In the Matter of)	
)	Docket 50-344
PORTLAND GENERAL ELECTRIC COMPANY,)	
et al)	(Control Building Proceeding)
)	
(Trojan Nuclear Plant))

I hereby certify that on July 10, 1979, Licensee's letter to the Director of Nuclear Reactor Regulation dated July 10, 1979 and an attachment entitled "Request for Additional Information, Trojan Nuclear Plant, Proposed Control Building Design", have been served upon the persons listed below by depositing copies thereof in the United States mail with proper postage affixed for first class mail.

Trojan Nuclear Plant
Docket 50-344
License NPF-1

Enclosed are the answers prepared by Bechtel Power Corporation to the remaining five questions from your letter of May 18, 1979. This submittal answers the last of the formal questions posed by your staff. A revision to PGE-1020 covering updated information will be issued shortly.

Figure 46-13 Secant Modulus, Specimen F-1

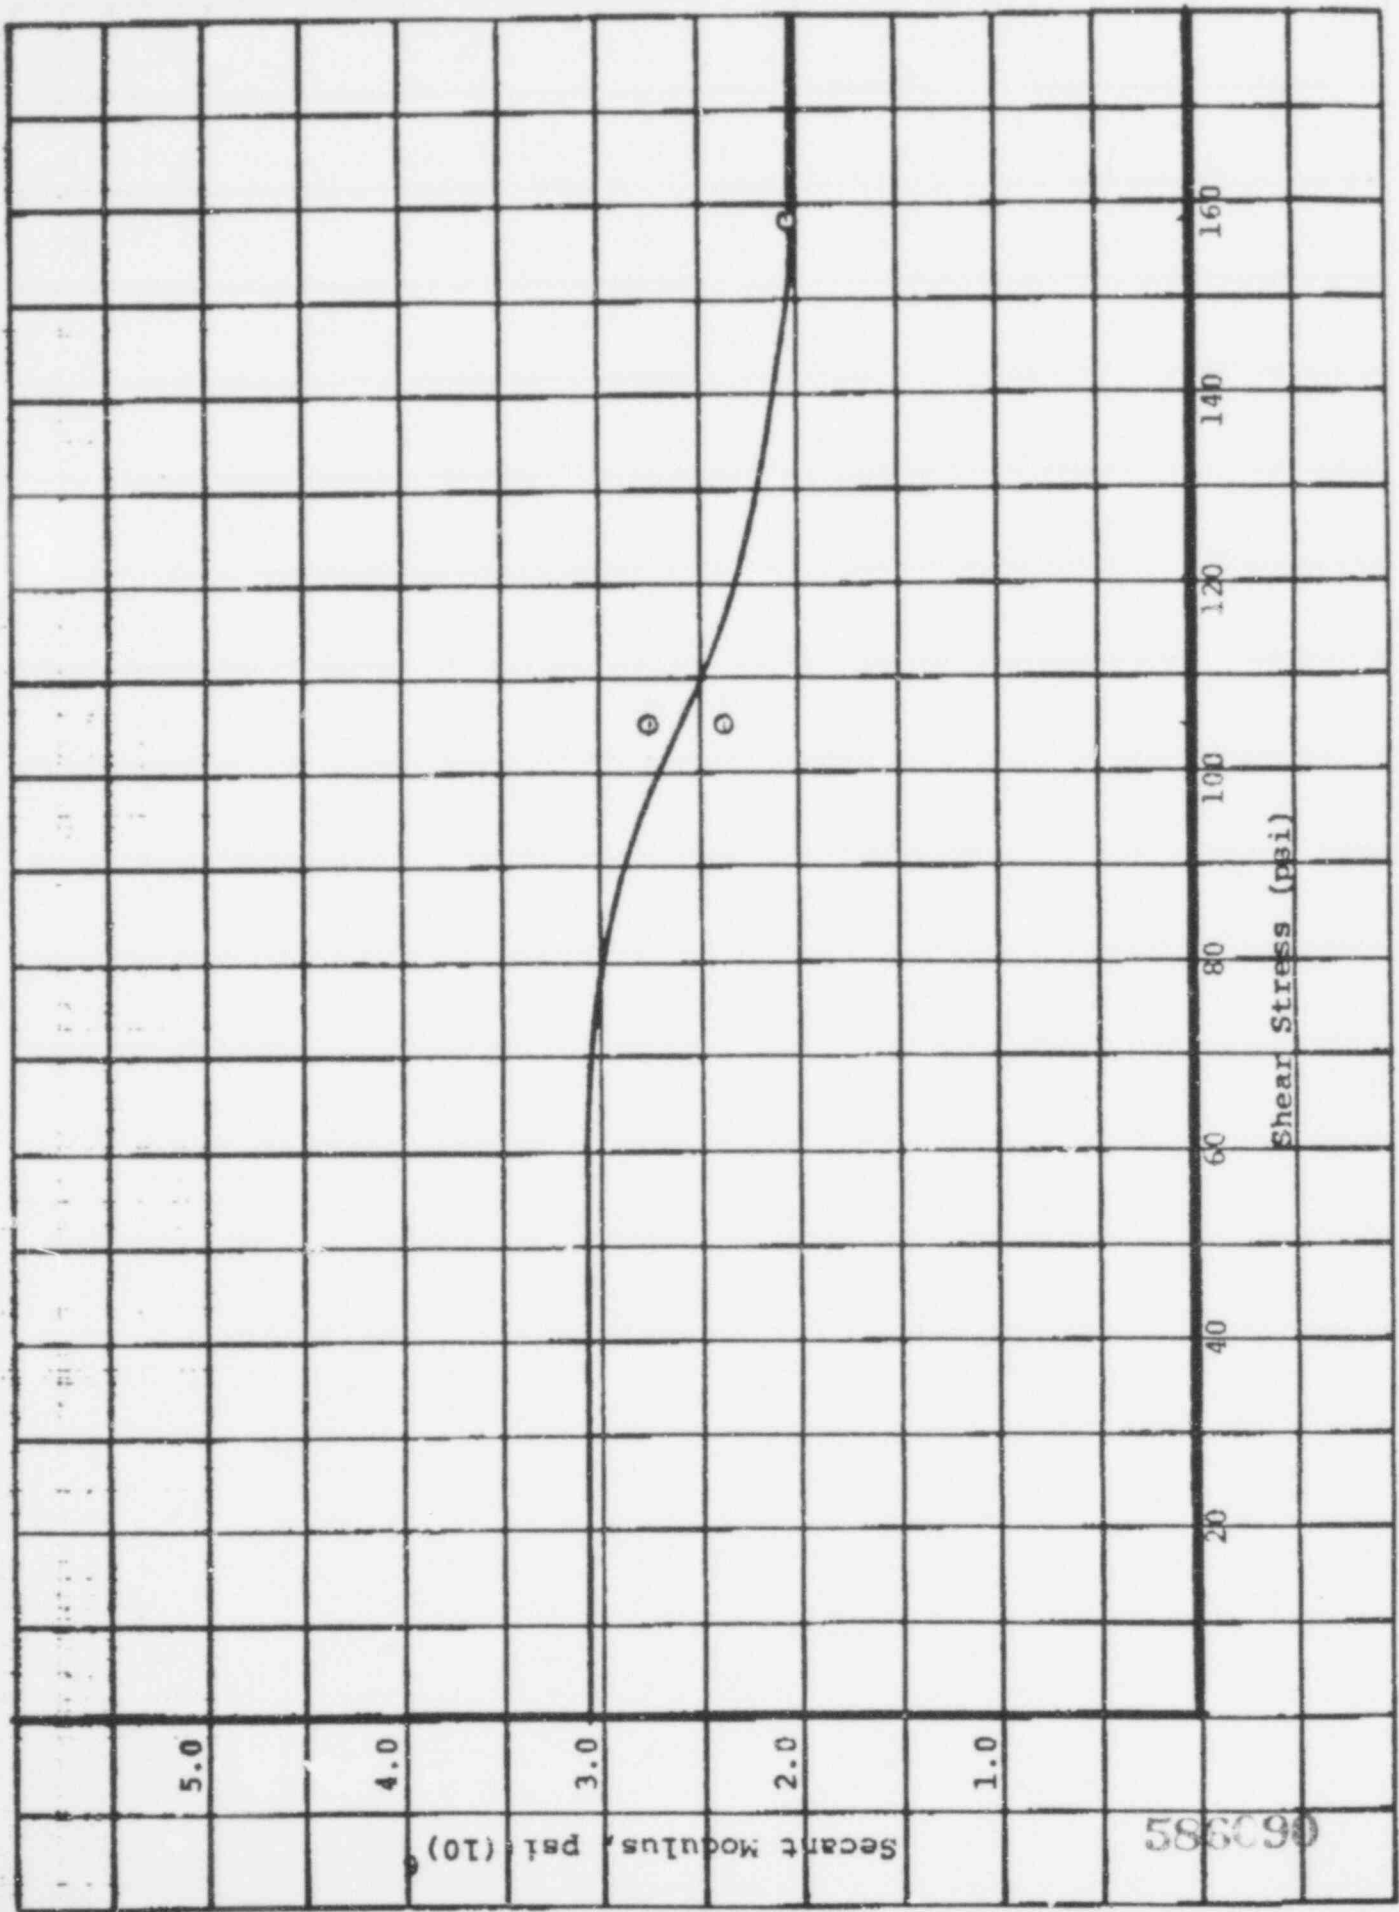
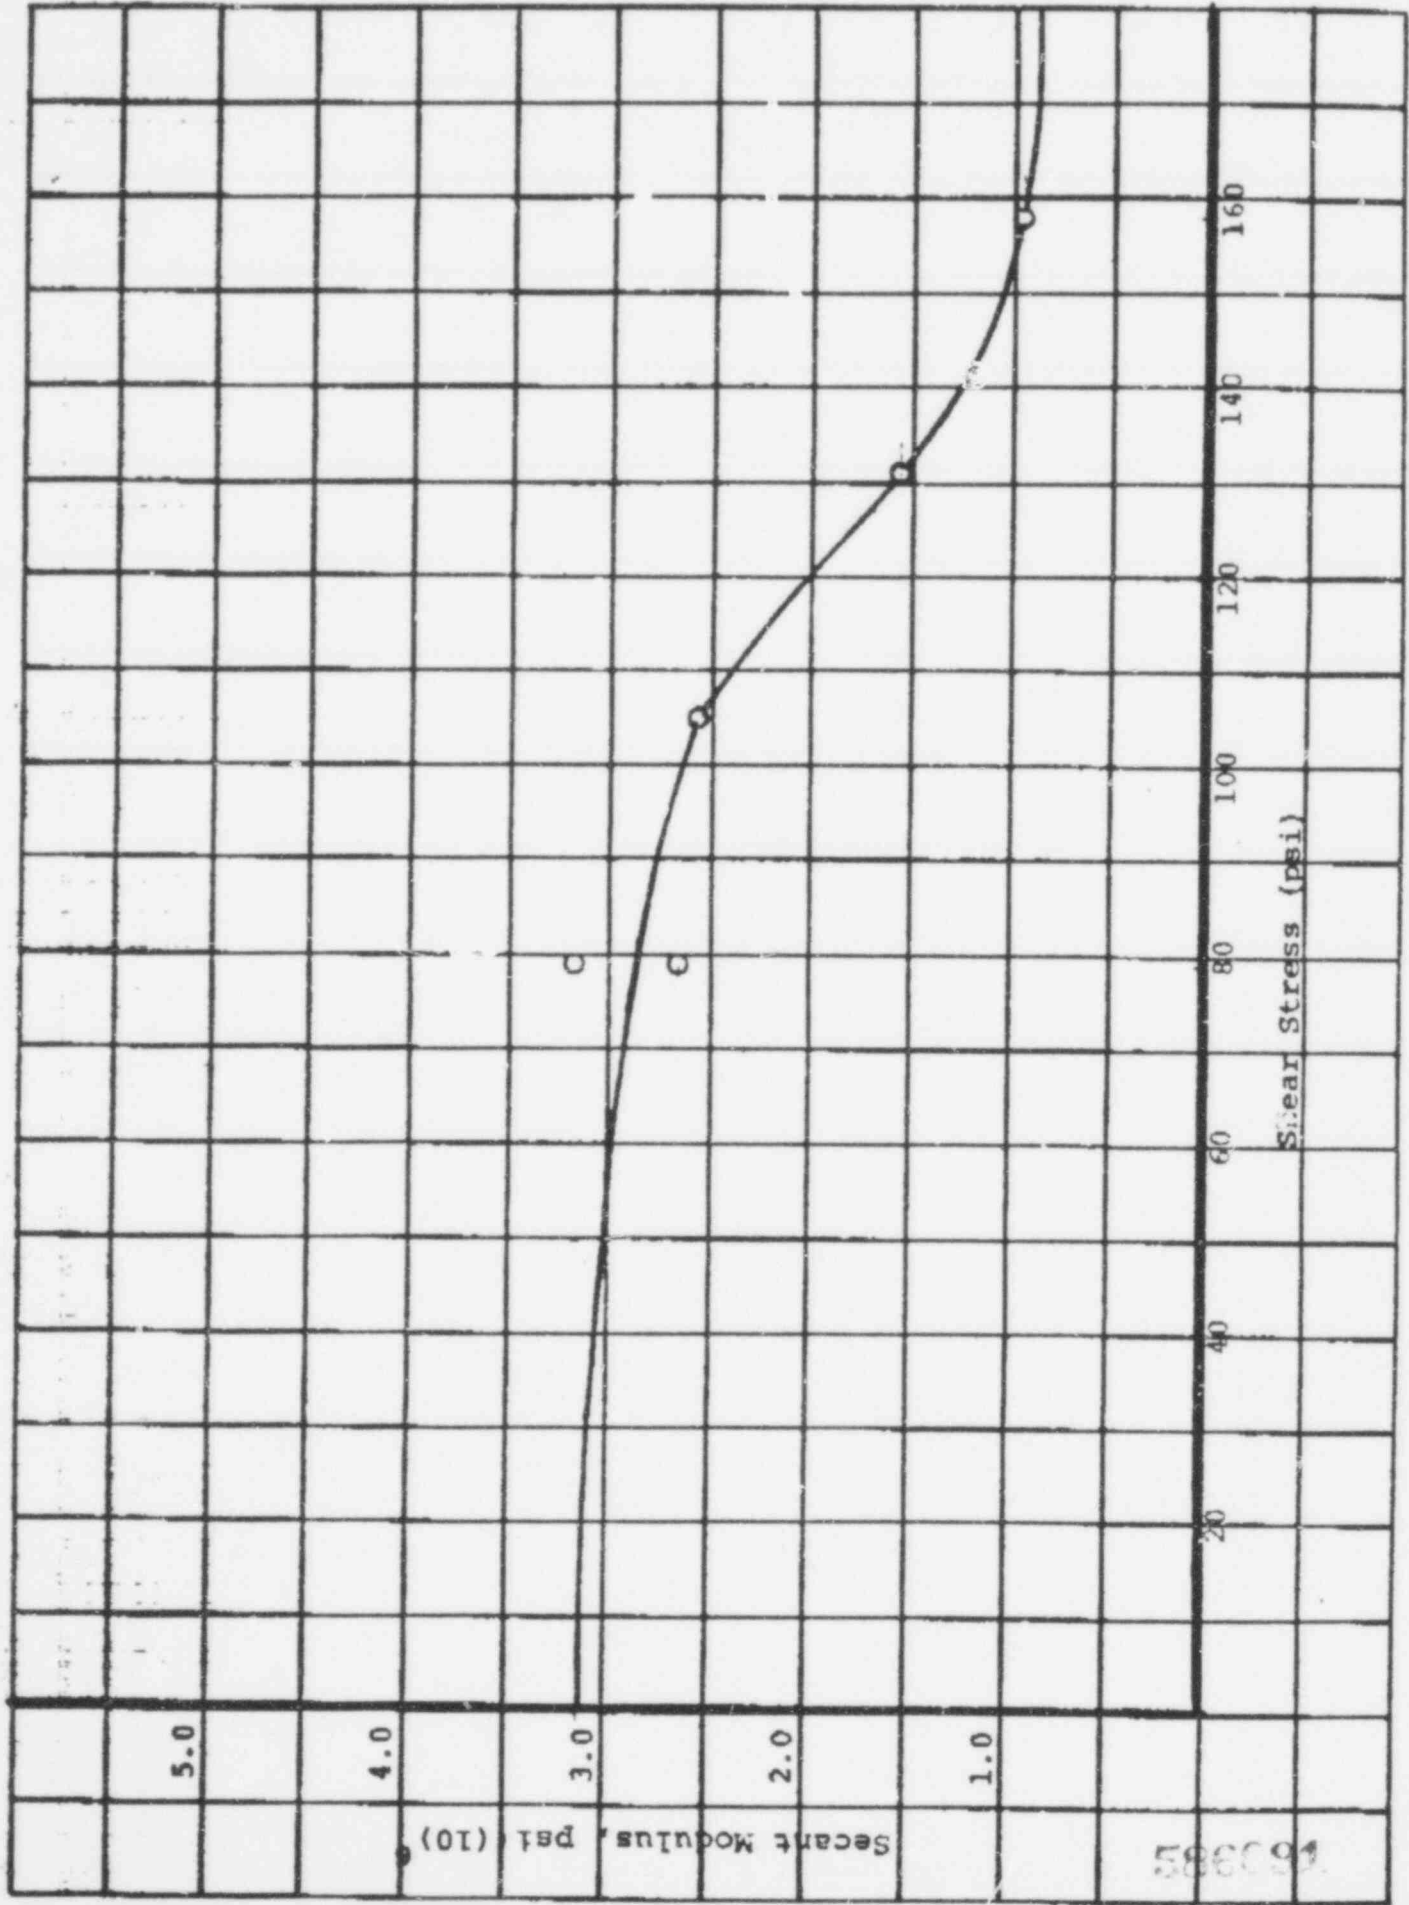
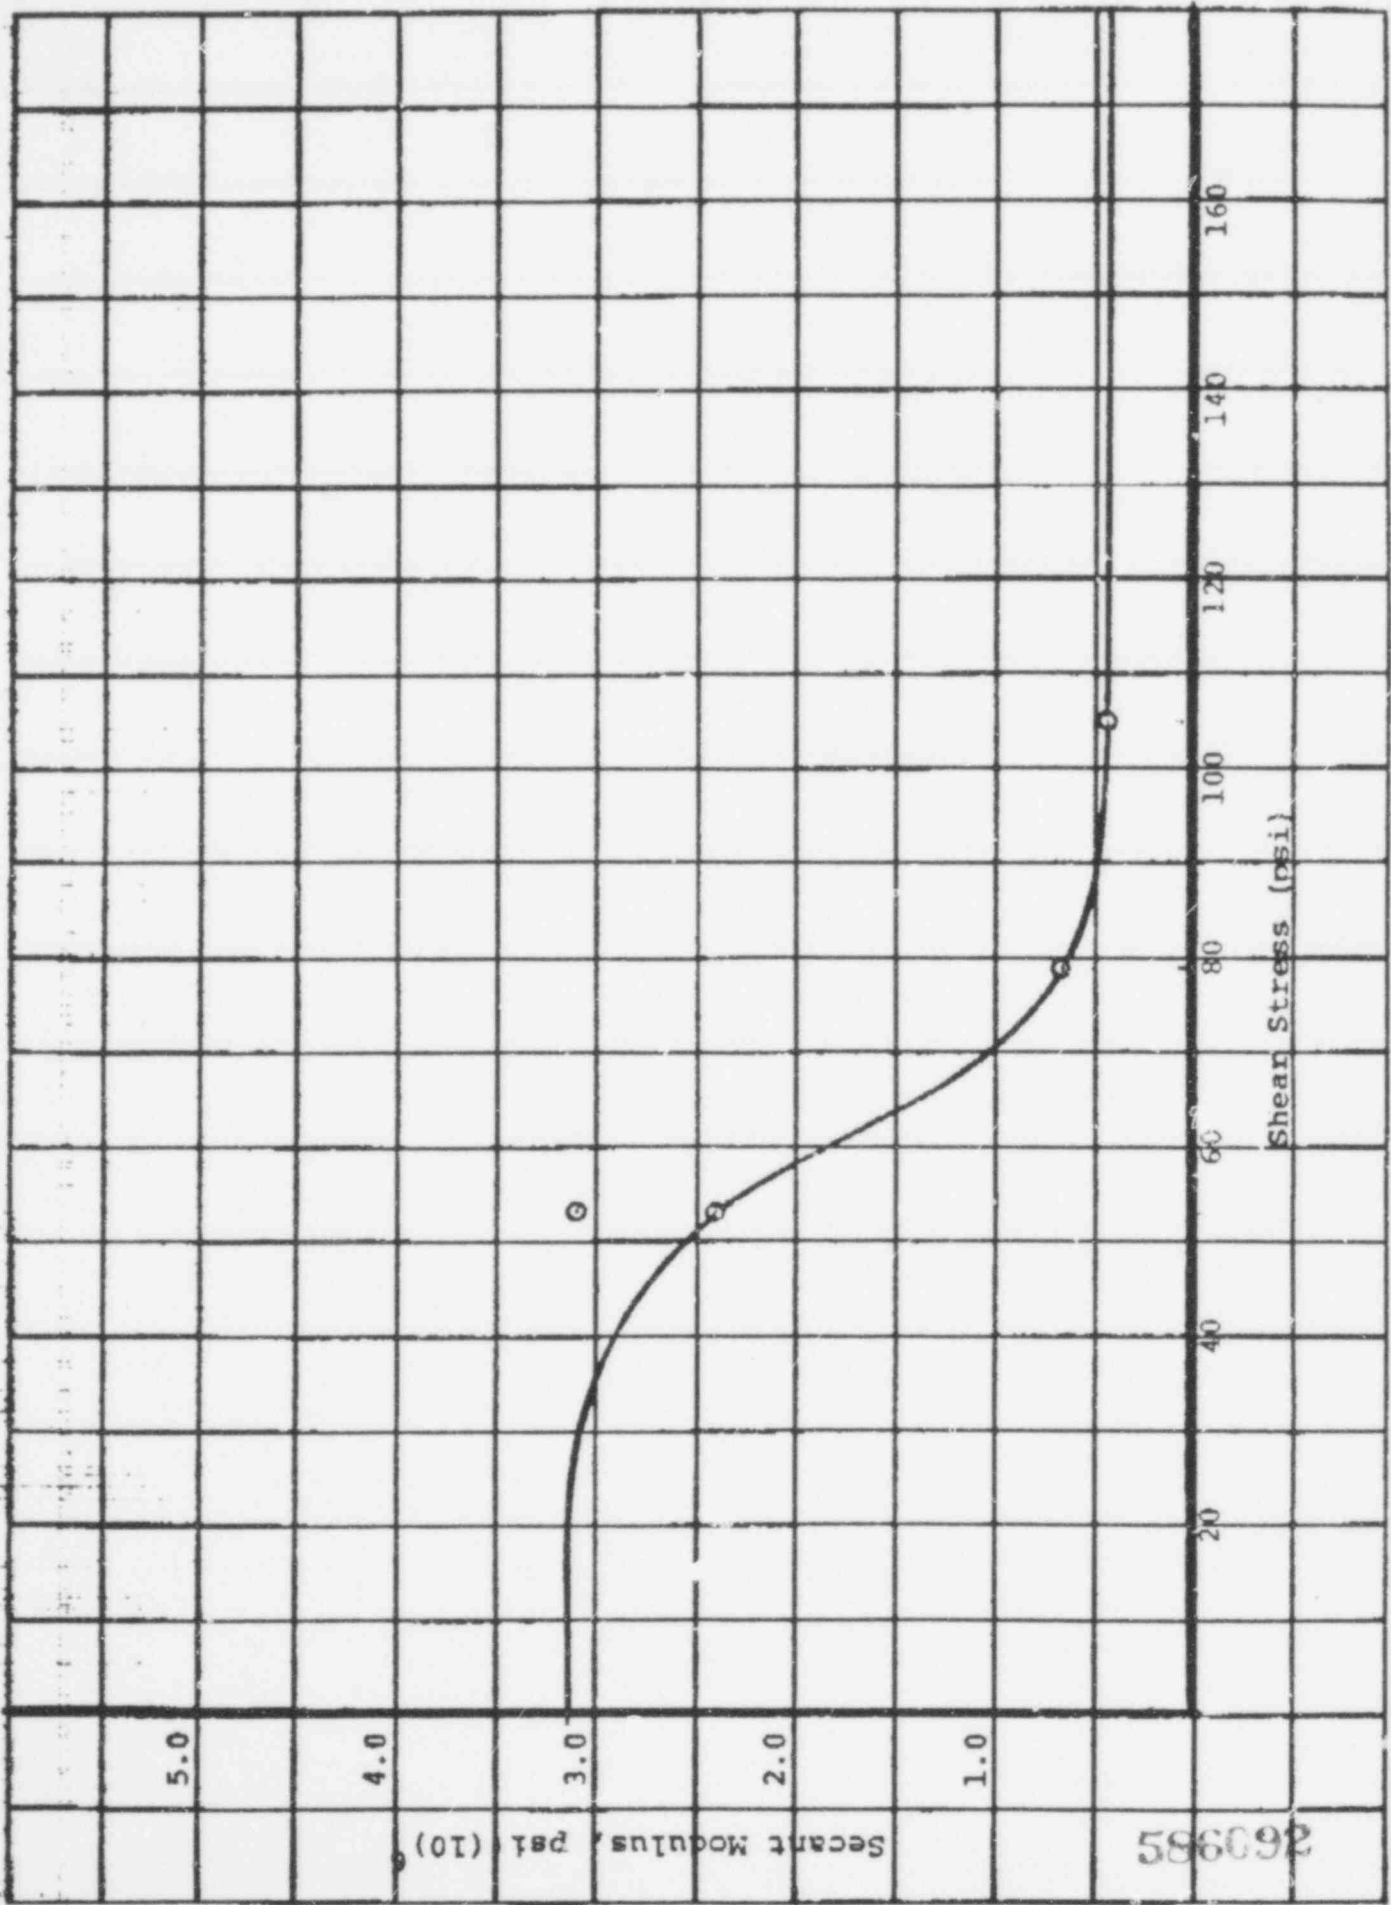
Provide the secant modulus derived for each of the test specimens vs. stress level; a comparison of the experimental initial elastic modulus for the test specimens vs. that calculated using the formula in Section 2.2.1.3.2 of Appendix B; the error bands, and their deviation, for the curves representing stiffness reduction as a function of stress level; and the stresses in each of the walls resulting from incorporation of the stiffness reduction factors in the STARDYNE model along with the associated stiffness reduction factors assumed in the analysis.

The secant modulus vs. shear stress for the test specimens is shown in Figures 46-1 through 46-20. A comparison between the experimental initial elastic modulus and that calculated using the formula in Section 2.2.1.3.2 of PGE-1020, Appendix B cannot be made since the initial modulus cannot be determined experimentally. The instrumentation was not sufficiently sensitive to measure the small deflections required for the calculation. Deflections need to be measured reliably to the nearest .0002 inch at the early stages of deformation. During this stage, the test specimen and load frame is settling in, play in instrumentation is being taken up, etc. Care was taken to minimize these effects but all could not be completely eliminated since the movements being considered are between 1 and 10 times smaller than the thickness of this paper. Some difficulty was even encountered at the first load step but for the other load steps the deflections were

large enough so that effects were not important. As shown in Figures 46-1 to 46-20, there are in general two data points at the first load step. The top part is obtained from the average deflections recorded on each side of the specimen and the other is obtained from the most active dial gauge. The initial modulus used in the plot was calculated using the equation in PGE-1020, Appendix B. An error analysis of the data could not be made since there are not enough specimens with duplicate conditions to provide sufficient data base. The effect of variation is considered in the broadening of the response spectra.
